ADDENDUM

PROJECT: Forestside Estates
Attmar & Palleschi Drive
Brampton, Ontario

ADDENDUM NO. M-04

PURPOSE: Revise mechanical layouts to suit latest architectural background.

DRAWN MC	CHECKED LM	SCALE 1:150
DATE MAY, 2019	PROJECT 18-017	DRAWING M-4
		OF

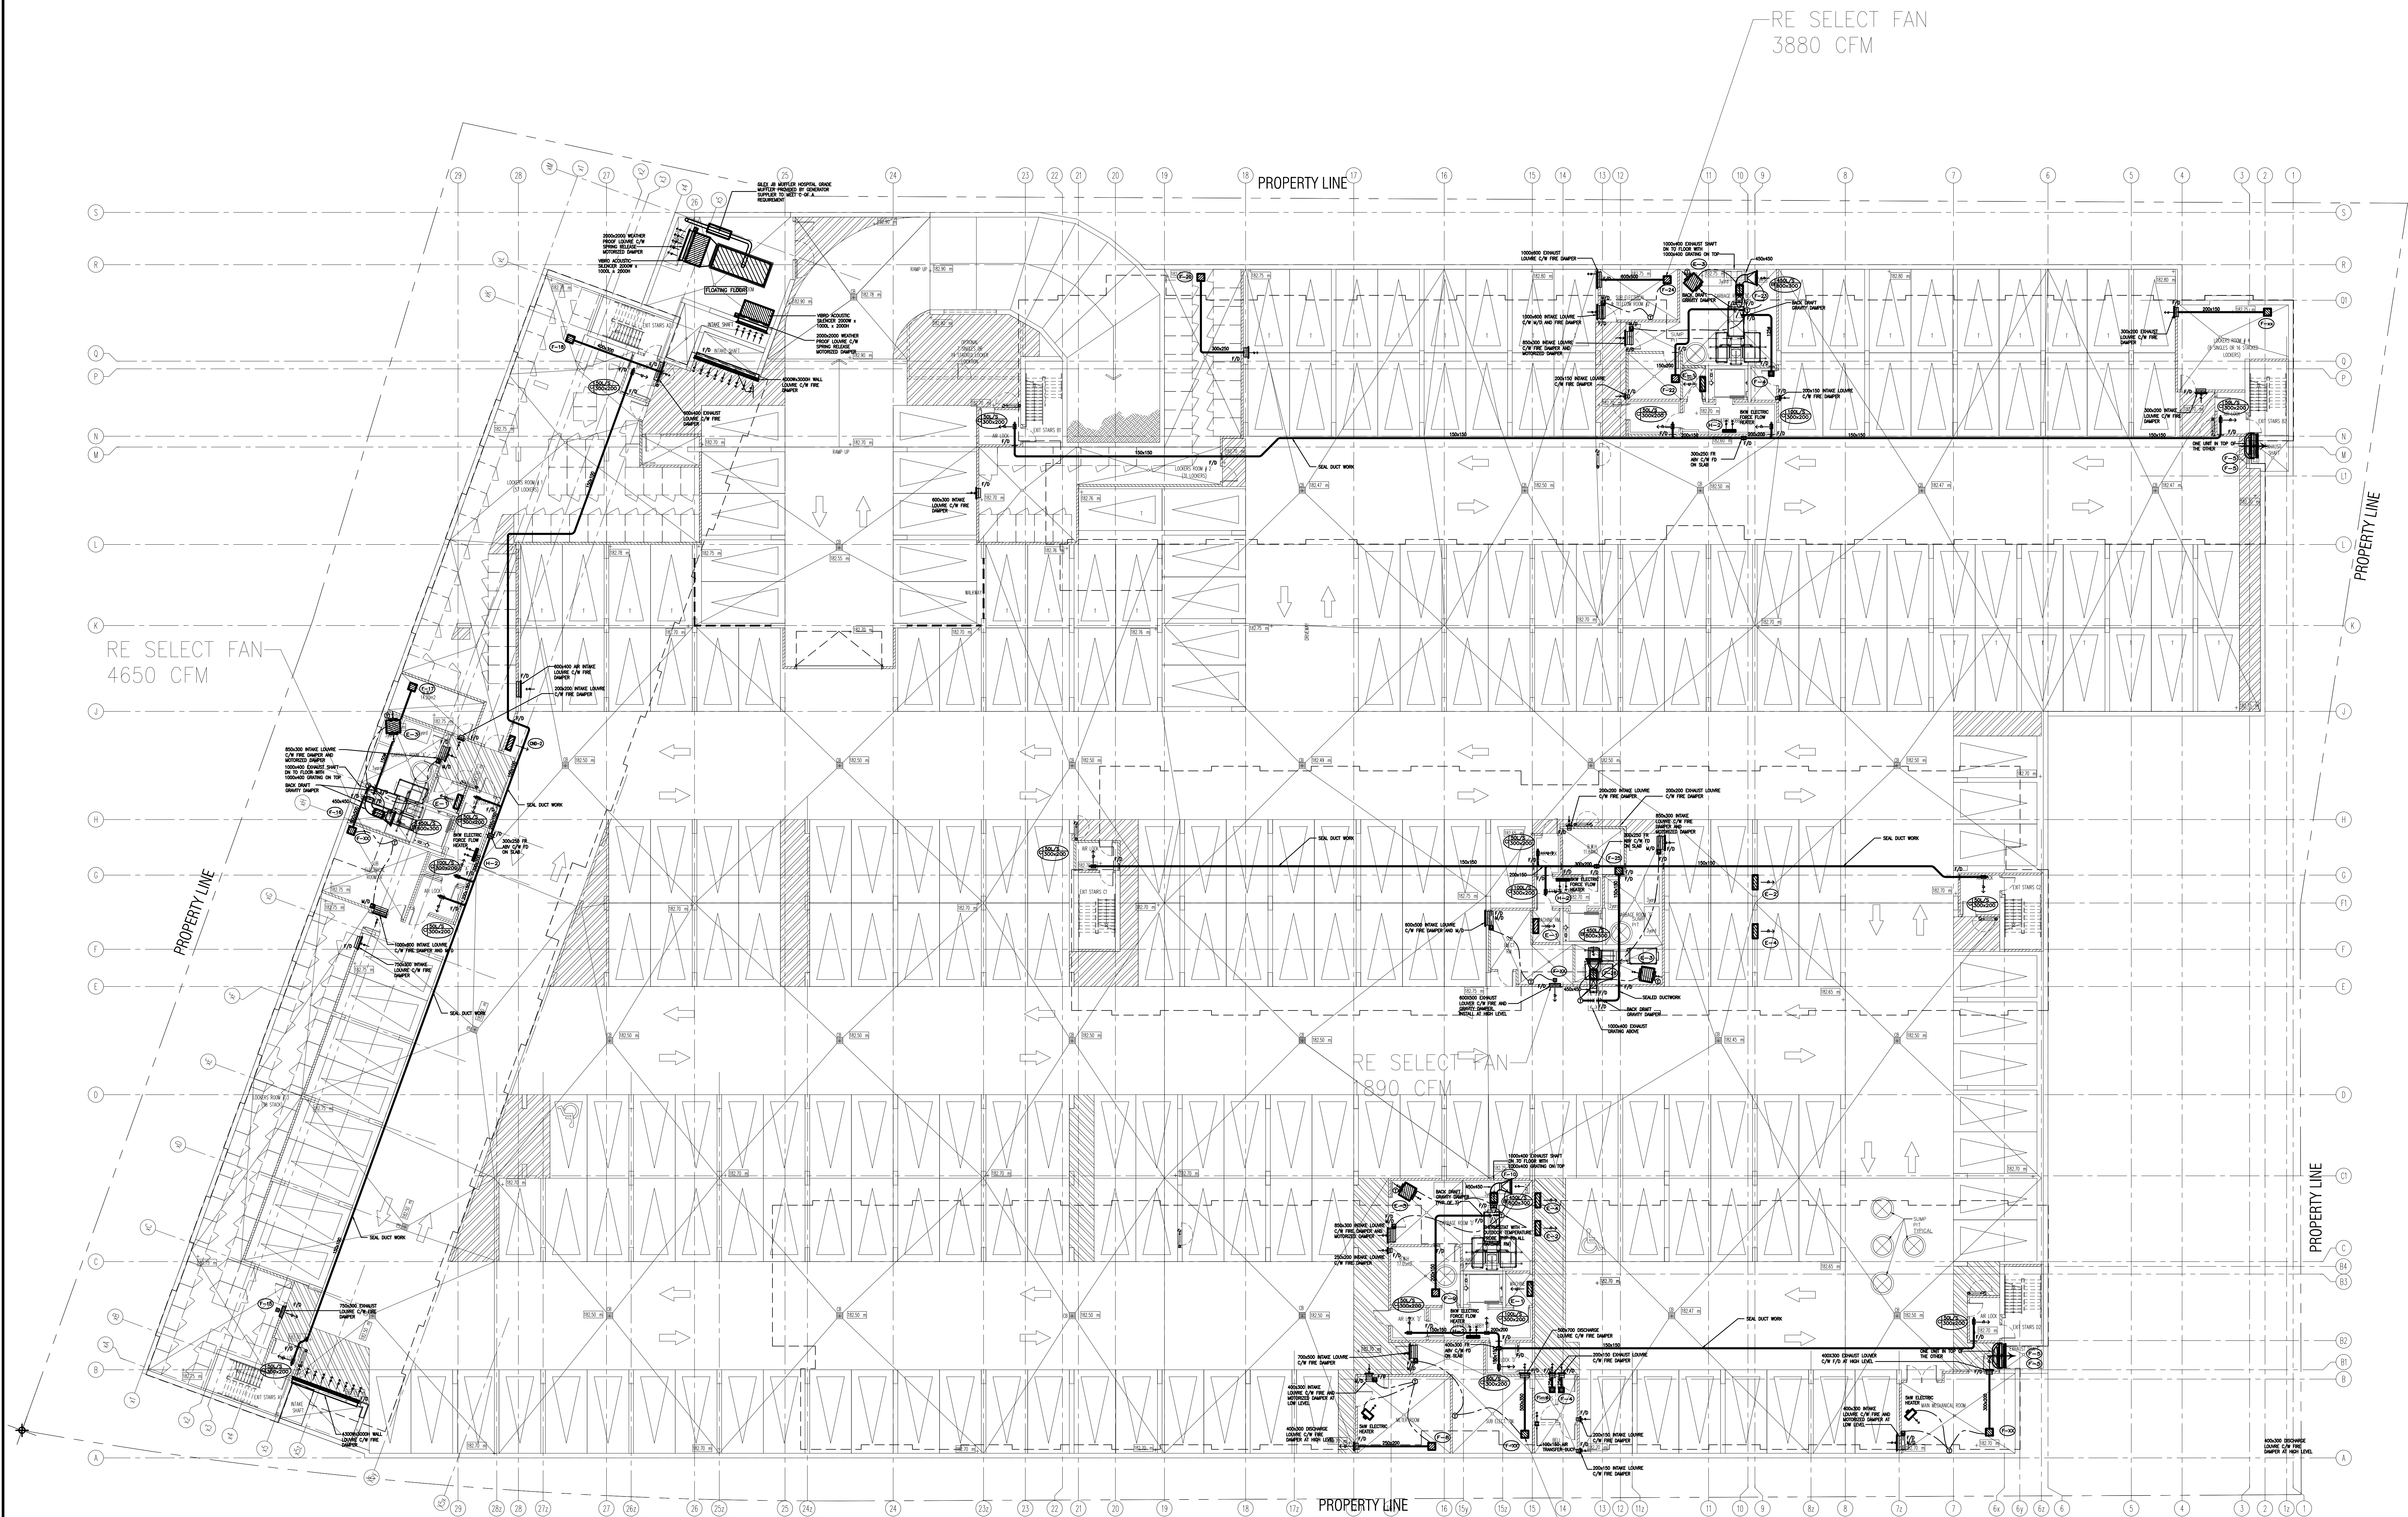
RE SELECT FAN
4650 CFM

RE SELECT FAN
890 CFM
